ADDENDUM #1
RFB #23-0051
LAKE AFTON PARK-PAVILION RENOVATIONS

Addendum Number One
To The Drawings and Specifications for
Lake Afton Park – Pavilion Renovations
Bid # 23-0051, Sedgwick County, Kansas

ADD BY ADDENDUM ONE - 9/18/23
1 TRENCH DRAIN
SCALE: 1" = 1'-0"

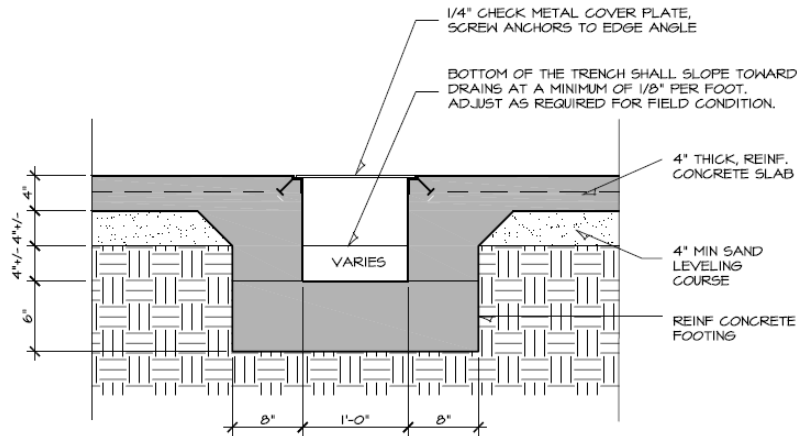
- d. Provide a 12" wide drainage flume through the sidewalk (with checked metal cover) to allow stormwater to flow towards the lake (not over the sidewalk). The detail below is being added to sheet D1.1, with this addendum.
